Access Compliance Report

Public Rights-of-Way

(Pedestrian Signals)

Intersection ID: N/A	Main Street:	Cross Street: N/A	Location: N/A
ADA ID: 1B8B3144F78C	Signal Type: Two Push Buttons-APS	Overall Compliance: No	Severity Score: BTN 1:N/A BTN 2: N/A No BTN: N/A
Codes/Mitigation Info/Possible Solution		Field Measurements/Component Compliance

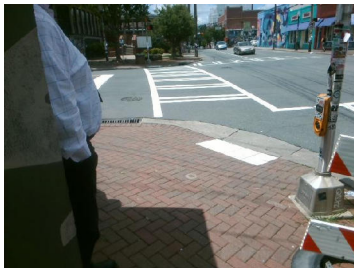
Surveyor Notes: TEXT HT 3/8, BITH SIGNALS
COVERED IN STICKERS

PROW/ADA: R410.6, R404.2, R404.3, R406.2,

Possible Solutions: Remove & Replace
Replace APS Button With New APS Button.
Remove and Replace Clear Space.
